IDAP REPORT

Property:	28 South Street Strathfield LOT 73 DP 8778 DA2022.06
Proposal:	Demolition of existing structures and construction of single-storey dwelling with a basement level, swimming pool and landscaping.
Applicant:	S Yako
Owner:	S C Ykmour
Date of lodgement:	24 January 2022
Notification period:	1 February 2022 – 16 February 2022
Submissions received:	Nil
Assessment officer:	L Gibson
Estimated cost of works:	\$1,989,900.00
Zoning:	R2-Low Density Residential - SLEP 2012
Heritage:	No
Flood affected:	No
Is a Clause 4.6 Variation Proposed:	No
RECOMMENDATION OF OFFICER:	APPROVAL

Figure 5: Proposed Basement Plan

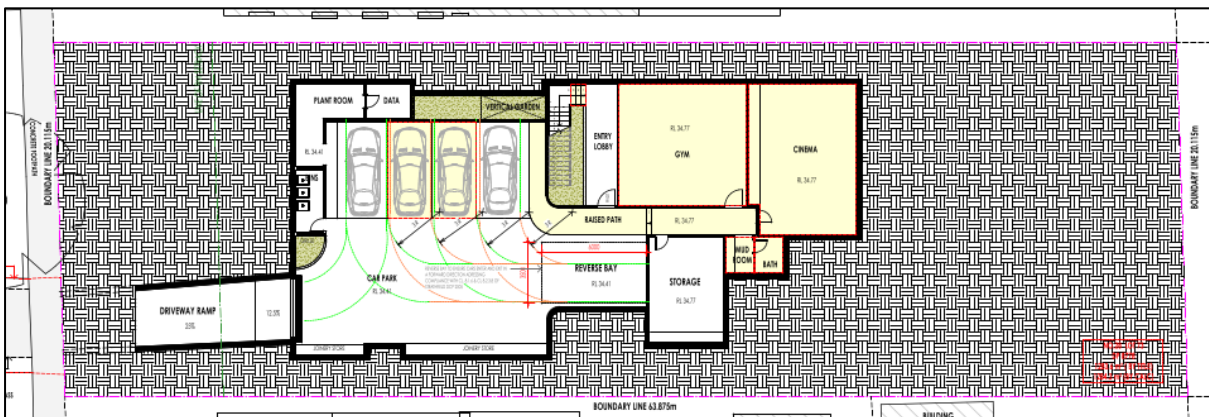
The proposed development satisfies the relevant objectives and controls of the SCDCP 2005 in that it provides the minimum number of required parking spaces and adequate vehicular access provisions. The basement has been kept to less than 1m above natural ground level.

As previously discussed, the proposed 3.36m floor to ceiling height of the basement results in excessive excavation on the site. Excavation should be minimised where possible to minimise soil disturbance. Accordingly, a condition of consent is recommend to ensure the maximum basement floor to ceiling height for the carpark and storage area exceeds no more than 2.4m from the floor. All other areas (cinema, gym, mud room, bathroom, raised path and entry lobby may have a floor to ceiling height of 2.8m. These floor to ceiling heights are inclusive of the cavity for mechanical services.

So to minimise unnecessary impact on adjoining properties, a condition of consent is recommend to ensure the maximum basement floor to ceiling height for the carpark and storage area exceeds no more than 2.4m from the floor. All other areas (cinema, gym, mud room, bathroom, raised path and entry lobby may have a floor to ceiling height of 2.8m. These floor to ceiling heights are inclusive of the cavity required for mechanical services.

Figure 6: Proposed Section Plan

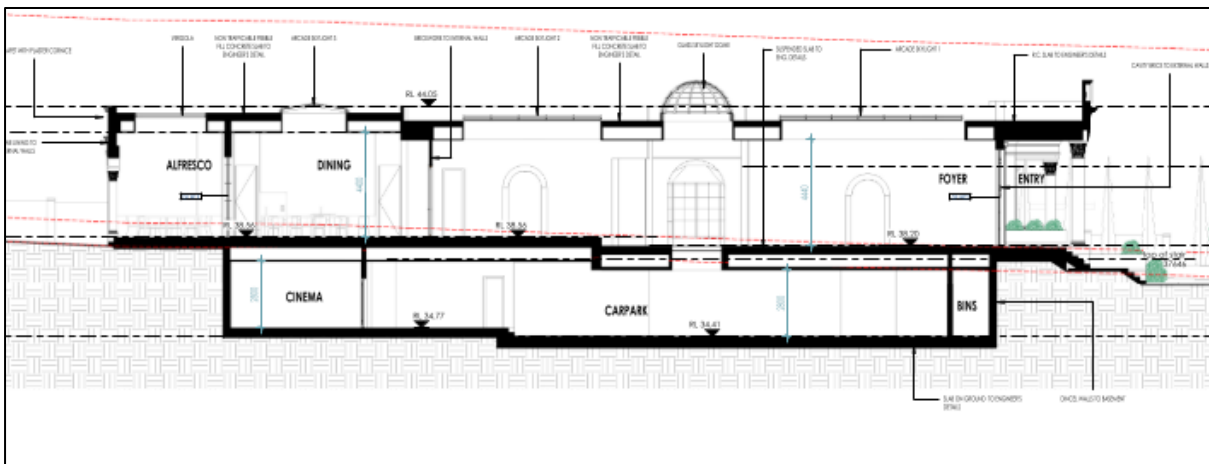
The proposal seeks construction of a basement which has been designed within the confines of the ground floor building footprint. Notwithstanding this, the proposed 3.36m floor to ceiling height of the basement results in excessive excavation on the site (refer back to Figure 6 above). Excavation should be minimised where possible to reduce soil disturbance and any undue impact on neighbouring properties.

Figure 13: Submitted Landscape Plan

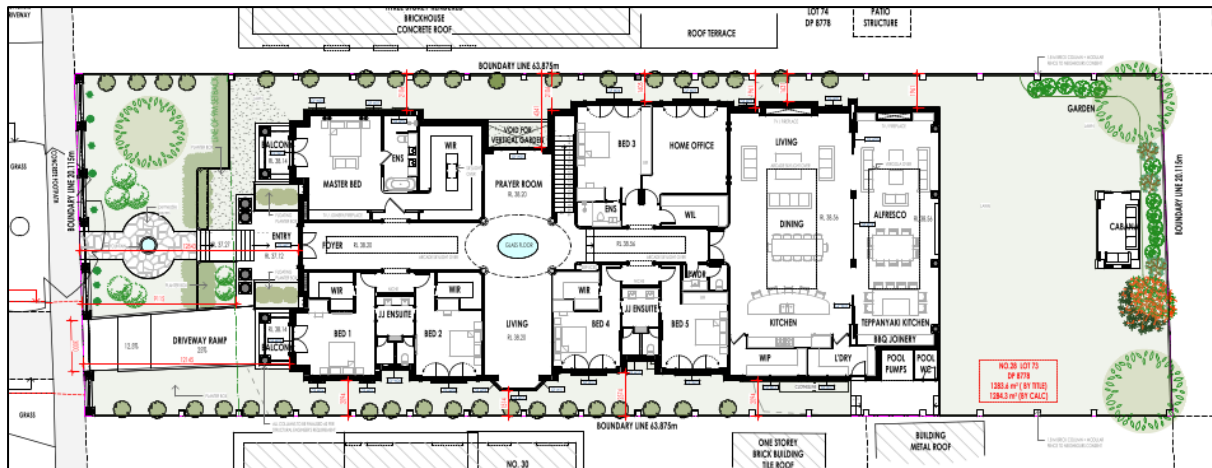
The plans have been amended during the assessment process so to achieve a compliant landscape scheme that is suitable to the scale of the development. The submitted landscape plan demonstrates a mixture of plant species proposed through the site including further embellishment with several canopy trees to the front and rear setback of the site. The proposed development satisfies the relevant objectives and controls of the SCDCP 2005.

Figure 14: Excerpt from submitted Streetscape Analysis Plan

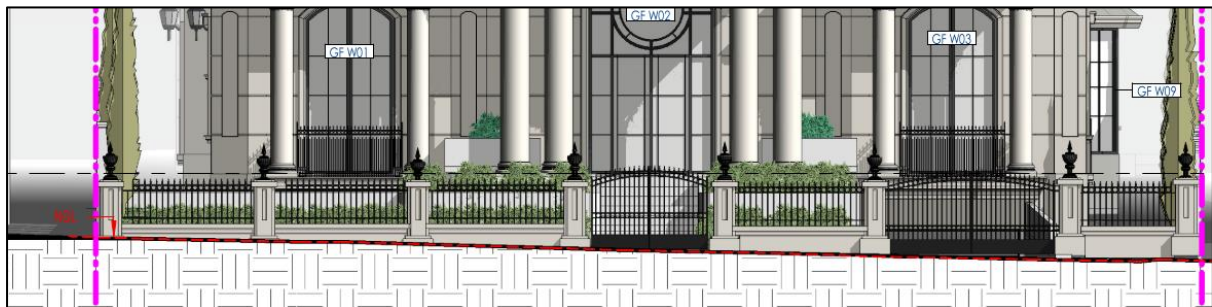
The proposal seeks a front boundary fence comprised of solid rendered masonry piers with metal batten infill. Whilst the fencing appears appropriate with regard to its design, the submitted documentation lacks sufficient detail to confirm the true height of the structure above Natural Ground Level. Accordingly, a condition of consent is recommended to ensure that the front fence is constructed to a maximum height of 1.5m (inclusive of decorative topper urn elements above the piers).

Amendments made in red on approved plans	All changes made in red on the approved plans shall be updated and shown on the Construction Certificate plans.
Fence Height	The front boundary fence height must not exceed 1.5m above the Natural Ground inclusive of decorative urn elements above the piers.
Deletion of pool pump area.	The pool pump area along the southern side boundary must be deleted.

Figure 17: Comparative Shadow analysis plan – 3pm

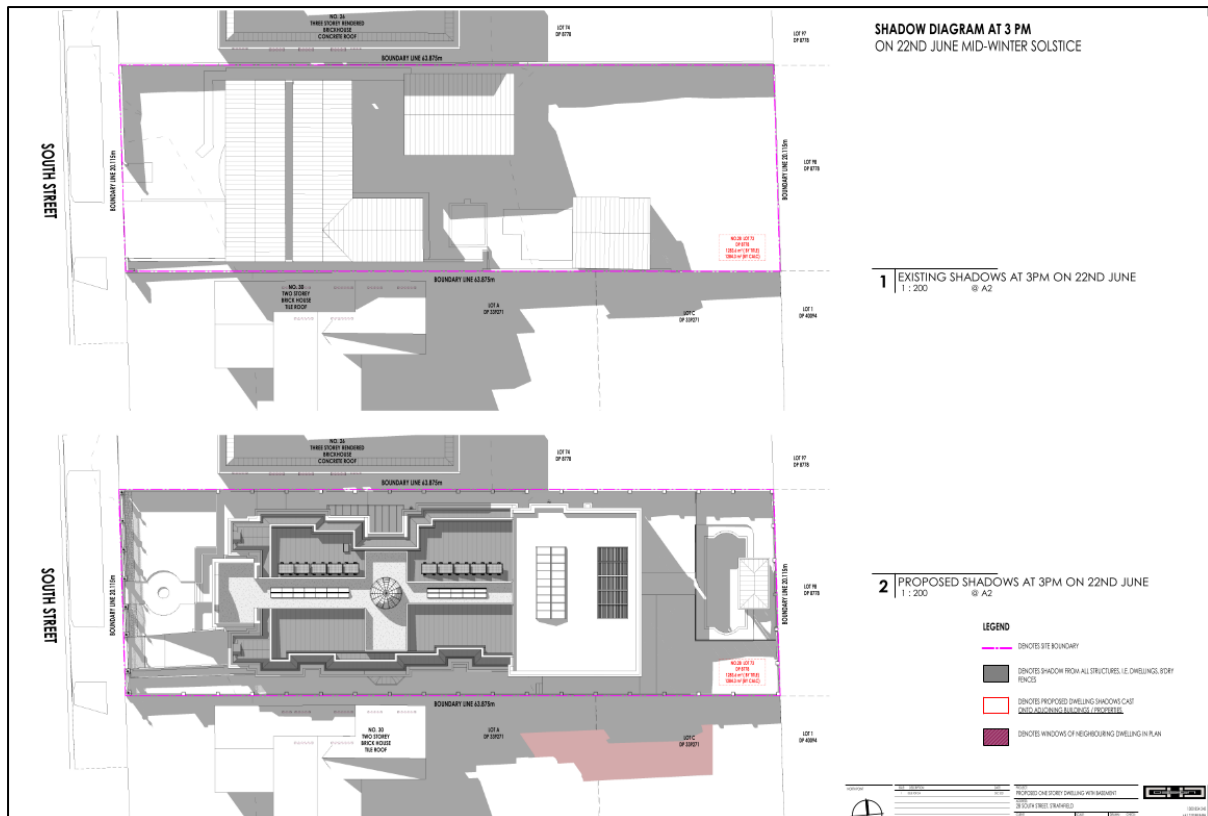
The site is provided with an east-west orientation resulting in an unavoidable degree of overshadowing to the southern adjoining heritage building. The application was accompanied by a comparative shadow analysis of the existing overshadowing (dwelling previously on site prior to demolition) and proposed overshadowing as a result of the proposed development (refer to Figures 15-17 below for reference). The diagrams demonstrate that the proposal will result in overshadowing to the southern adjoining property at 30 South Street similarly to that of the dwelling that previously existed on the subject site. A total of 3 windows to the north face of 30 South Street will continue to receive minimal solar access through the day as a result of the proposal. Notwithstanding, the windows and openings to the dwelling's eastern and western face will continue to receive unimpeded solar access through the day.

It is further noted that these diagrams are indicative of the worst case scenario being the winter solstice. The dwelling will receive improved solar access at all other times of the year.
